VIRGINIA ELECTRIC AND POWER COMPANY  
RICHMOND, VIRGINIA 23261

December 17, 1996

Serial No. 96-599  
NL&OS/GSS/ETS  
Docket Nos. 50-338  
50-339  
License Nos. NPF-4  
NPF-7

**VIRGINIA ELECTRIC AND POWER COMPANY**  
**NORTH ANNA POWER STATION UNITS 1 AND 2**  
**PROPOSED TEMPORARY TECHNICAL SPECIFICATIONS CHANGE**  
**SERVICE WATER SYSTEM PIPING REPAIR/REFURBISHMENT**

FIGURE 1  
SIMPLIFIED FLOW DIAGRAM - SW PIPING TO/FROM CCHXS  
NORMAL ALIGNMENT

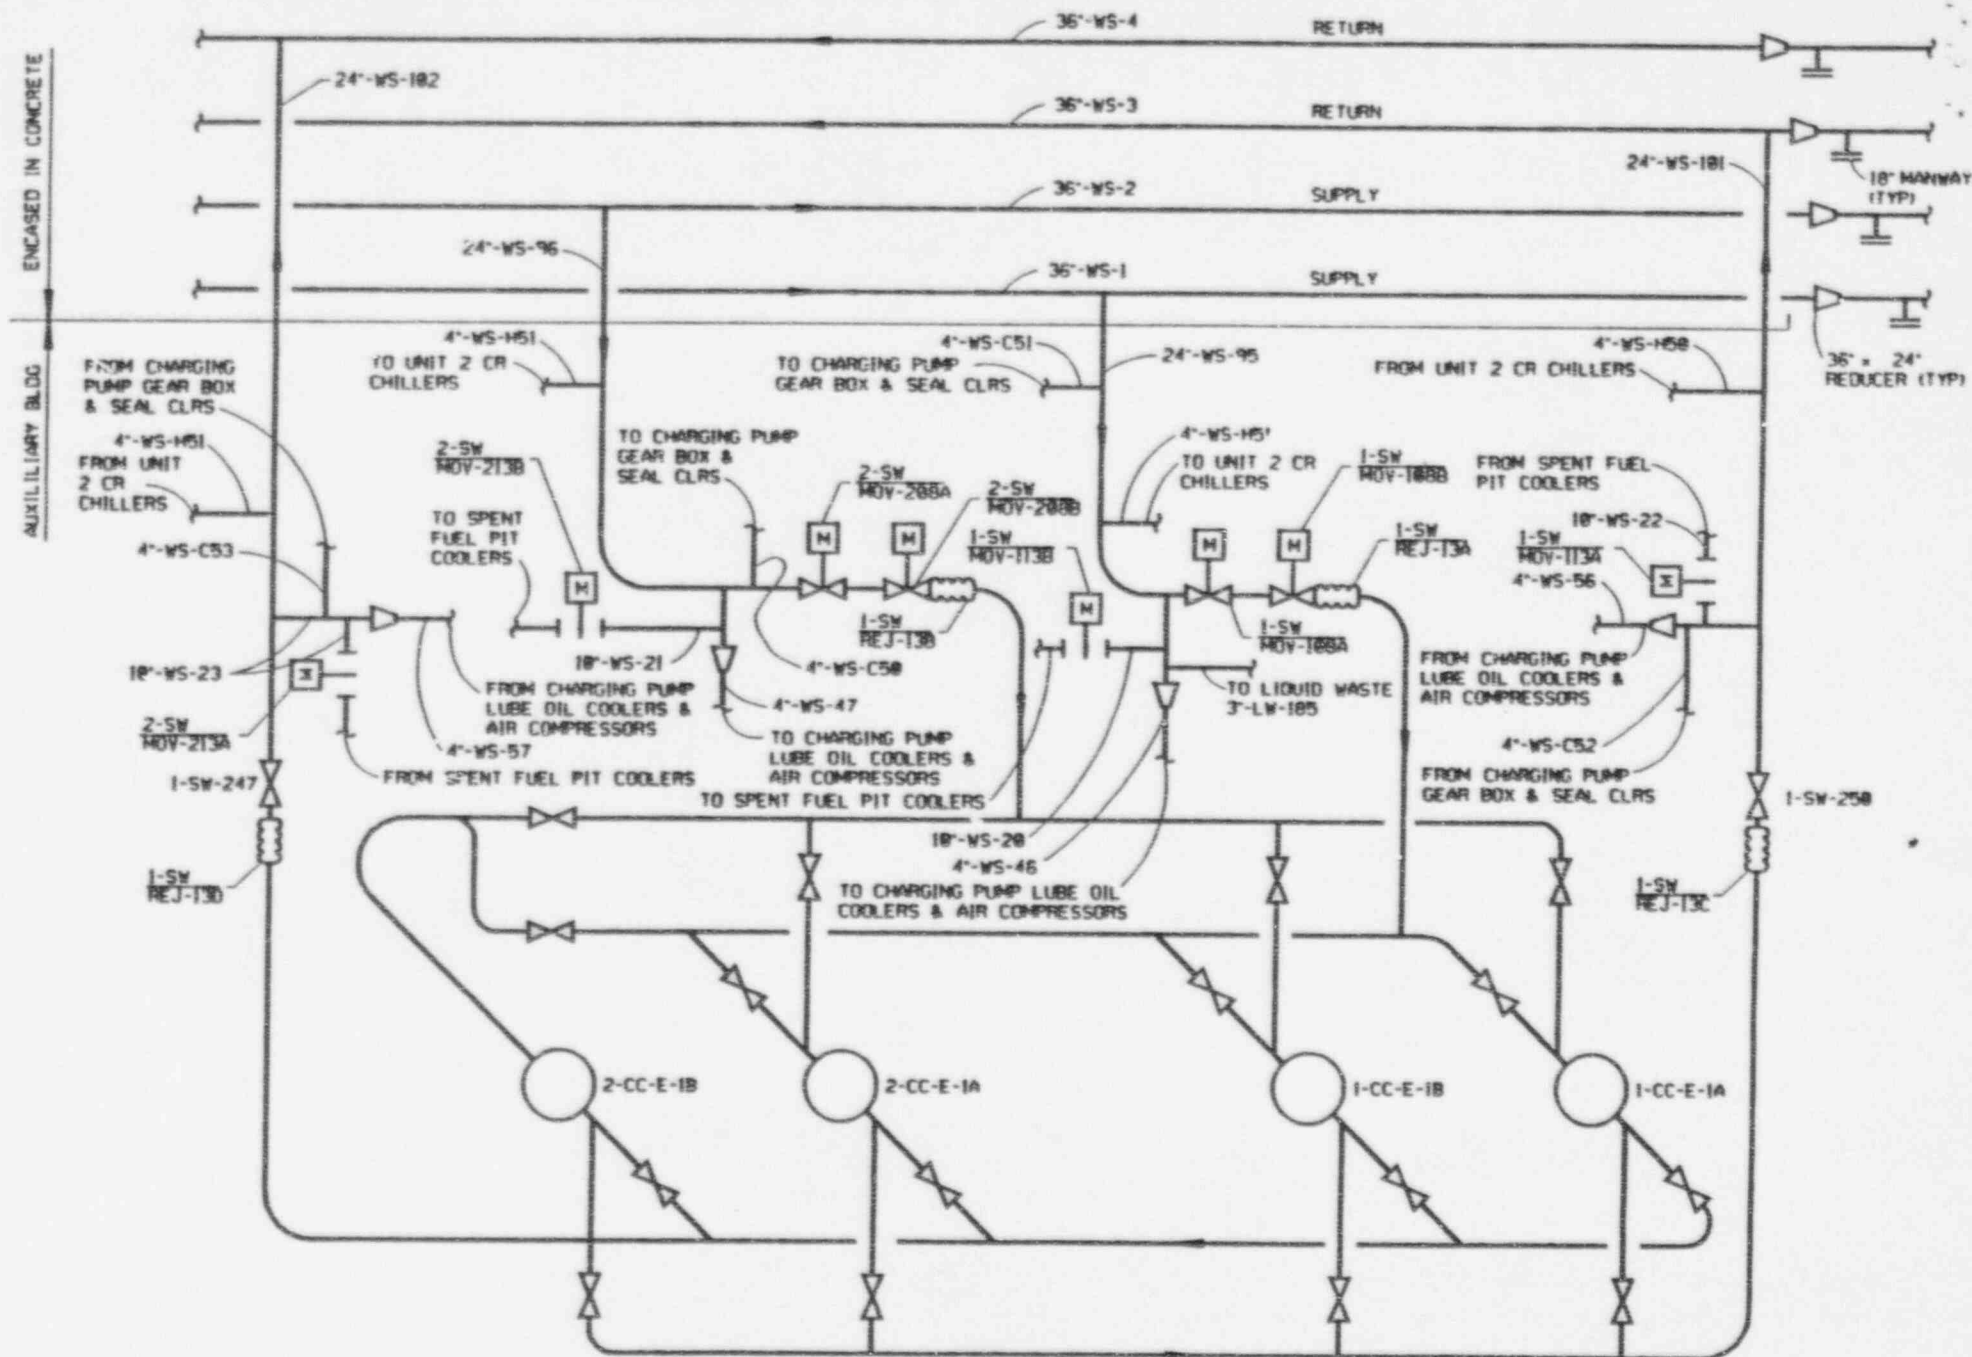
From Figure 1, it can be seen that each of the four CCHXs, each branch to the charging pump coolers, air compressor coolers, SFP coolers and Unit 2 CR chillers can be aligned to either of the "A" or "B" main SW loops. This provides an adequate level of operational flexibility and redundant SW supply during normal operating and outage conditions. However, the existing Technical Specifications do not permit isolation of this portion of the SW system for more than a 168-hour (7-day) period and this is insufficient time to perform the necessary repairs/replacements.

- First, it is necessary to isolate and blank the 24-inch SW header to/from the CCHXs and the above mentioned SW consumers. This is accomplished by isolating the entire "A" SW header using Action Statement "d" (the 168-hour Action Statement) of Technical Specification 3.7.4.1 and performing the following in sequence (refer to Figures 1 and 2):

- 1) Re-align SW system to supply all applicable loads from the "B" main header and enter the 168-hour Action Statement on the "A" main header.
- 2) Drain the "A" main supply and return piping.
- 3) Remove valves 1-SW-MOV-108A, 1-SW-MOV-108B, 1-SW-247 and expansion joints 1-SW-REJ-13A and 1-SW-REJ-13D. Install blind flanges in place of expansion joints 1-SW-REJ-13A and 1-SW-REJ-13D.
- 4) Install weld-in plugs in pipes 24"-WS-95-151-Q3 and 24"-WS-102-151-Q3 as close to 36" header as practical.

5) Install crossconnect 18"-WS-J01-151-Q3 and connect lines 10"-WS-J04-151-Q3 and 10"-WS-J03-151-Q3. Simultaneously connect the above 10" lines to valves 1-SW-MOV-113B and 2-SW-MOV-213A and 4" lines as shown on Figure 2.

4) Crossconnect will be disassembled and piping alignment will be returned to normal (Figure 1).
